YELLOWSTONE COUNTY BOARD OF PLANNING
CITY OF BILLINGS AND
YELLOWSTONE COUNTY, MONTANA

AGENDA

January 26, 2016 MEETING TIME: 6:00 p.m.
1st Floor Large Conference Room, Miller Building
2825 3rd Avenue North, Billings, Montana 59101

PRELIMINARY PLAT OF GLYNN ABBEY SUBDIVISION

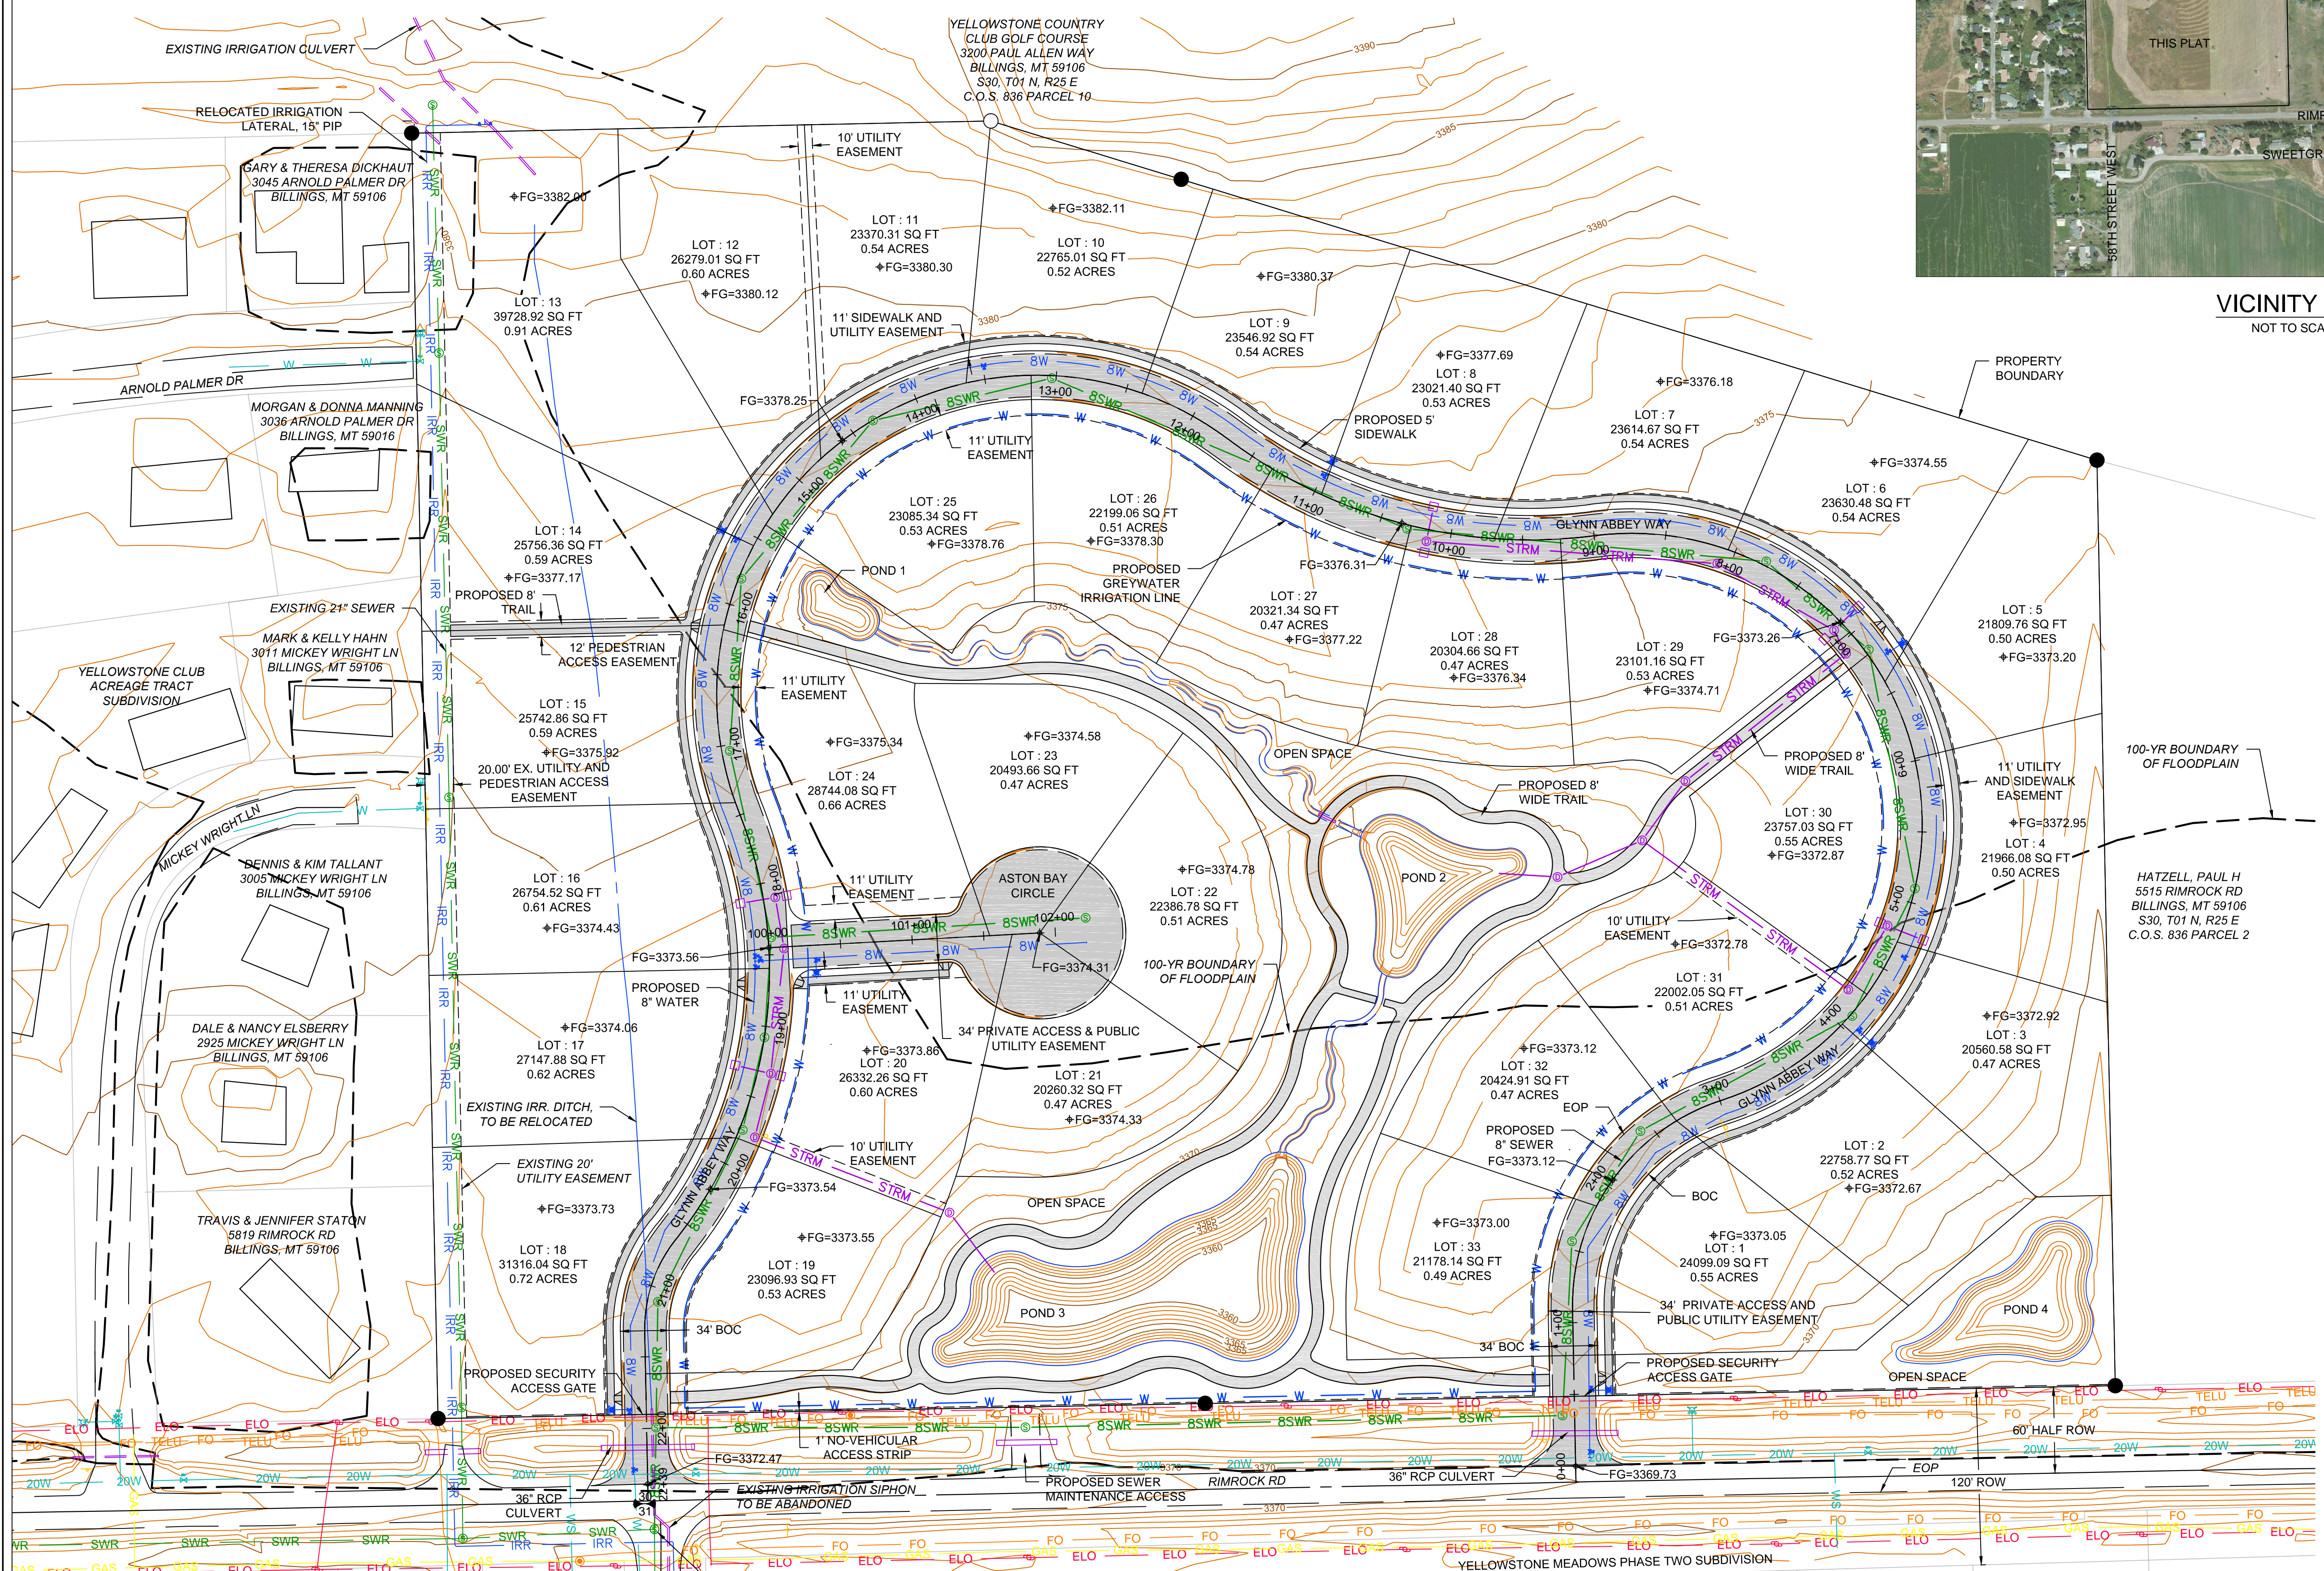
One variance is regarding provision of sidewalks on both sides of all of the internal streets in the subdivision. The applicant is requesting a variance to provide boulevard style sidewalk on only the north side of Glynn Abbey Way and not on either side of Aston Bay Circle. In lieu of complete boulevard sidewalk within the subdivision, the applicant is proposing to utilize an internal trail network that runs behind the lots on the south side of Glynn Abbey Way and may provide pedestrian connections to the lots in the subdivision. Justification for the variance request is provided by the applicant in an attachment to this memo. It is important that the Yellowstone County Board of Planning understand that it is the Board that may choose to recommend to the City Council that the sidewalk requirements be waived or modified for local residential streets as per Section 23-406 (B)(13) CSR.

Planning and Engineering staff are not in support of the proposed sidewalk variance and recommend that boulevard sidewalks be installed on both sides of Glynn Abbey Way and Aston Bay Circle throughout the subdivision. Staff's recommendation is based primarily on the safety of pedestrians circulating within the subdivision and access for pedestrians to neighboring lots in the subdivision. Other benefits of boulevard sidewalks include snow storage, off-street and off-sidewalk location for garbage and yard waste bins, landscaping, and in some cases mail delivery.

The second variance is regarding the requirement Section 23-406(A)(8) that streets in a new subdivision that are aligned with existing streets shall have matching names. The proposed internal Glynn Abbey Way is aligned with 58th Street West where it intersects Rimrock Road on the west side of the subdivision. The applicant is proposing that 58th Street West not continue across Rimrock Road but have the name change to Glynn Abbey Way when it enters the subdivision. The City's Address Coordinator, City Fire Department, and County GIS (manages the street name database for emergency services), all support this variance request for the change in street name on the 58th Street West alignment.

The Planning Board questioned whether the existing 20-foot-wide utility easement along the west side of the property also included public access to facilitate pedestrians using the proposed sidewalk from Mickey Right Lane and Arnold Palmer Drive to Glynn Abbey Way. Planning Division Manager Wyeth Friday said he was not sure how the easement was written and he would follow up with City Engineering on the issue. Since the plat review, staff has checked the easement language and it currently does not provide for public pedestrian access. A new condition has been added to address this issue (See Condition #9).

The subdivider is proposing to have boulevard-style sidewalks along the outer edge (north side) of Glynn Abbey Way and a short boulevard sidewalk segment along the south side of Aston Bay Circle. These are shown on the preliminary plat. As discussed in the Variance section of the memo for this preliminary plat and in the variance attachments, the subdivider is requesting a variance from the requirement to provide boulevard sidewalks on both sides of the streets in the subdivision. The subdivider is proposing that the variance be granted since the development will provide an interior trail system in the park land on the inner (or south side) of Glyn Abbey Way that will serve as pedestrian access and connectivity in lieu of sidewalk along the lot frontages. Justification for the variance request is provided by the applicant in an attachment to this memo and City staff's reasons for not supporting the variance are outlined in the Variances Requested portion of the memo. It is important that the Yellowstone County Board of Planning understand that it is the Board that may choose to recommend to the City Council that the sidewalk requirements be waived or modified for local residential streets as per Section 23-406 (B)(13) CSR.

Since the sidewalk referenced above from Mickey Wright Lane and Arnold Palmer Drive will utilize the existing 20-foot wide utility easement along the western boundary of the subdivision, the easement must be updated to reflect public pedestrian access is allowed. Prior to final plat approval the subdivider will provide a revised public access and utility easement documents for recording that ensures that both utility and public pedestrian access is allowed on the 20-foot-wide utility easement on the west boundary of the subject property (**See Condition #9**).

9. To minimize the effects on local services and ensure public pedestrian access on the 20-foot-wide utility easement on the western boundary of the subject property, prior to final plat approval the subdivider will provide a revised public access and utility easement documents for recording that ensures that both utility and public pedestrian access is allowed on the 20-foot-wide utility easement on the west boundary of the subject property.

10. To ensure connectivity between the subject property and existing neighborhoods to the west, the subdivider will update Section III (B) of the SIA to clarify that at time of construction of the sidewalks and trails within the subdivision, a 6-foot wide sidewalk will be constructed from where the public right-of-way for Mickey Wright Lane and Arnold Palmer Drive meet the subject property line and the 20-foot-wide public access and utility easement to where the 8-foot-wide trail between Lot 14 and Lot 15 is being built to connect to sidewalk on Glynn Abbey Way and the internal trail system in the open space of the subdivision.

To ensure connectivity between the subject property and existing neighborhoods to the west, the subdivider will update Section III (B) of the SIA to clarify that at time of construction of the sidewalks and trails within the subdivision, a 6-foot wide sidewalk will be constructed from where the public right-of-way for Mickey Wright Lane and Arnold Palmer Drive meet the subject property line and the 20-foot-wide public access and utility easement to where the 8-foot-wide trail between Lot 14 and Lot 15 is being built to connect to sidewalk on Glynn Abbey Way and the internal trail system in the open space of the subdivision (**See Condition #10**).
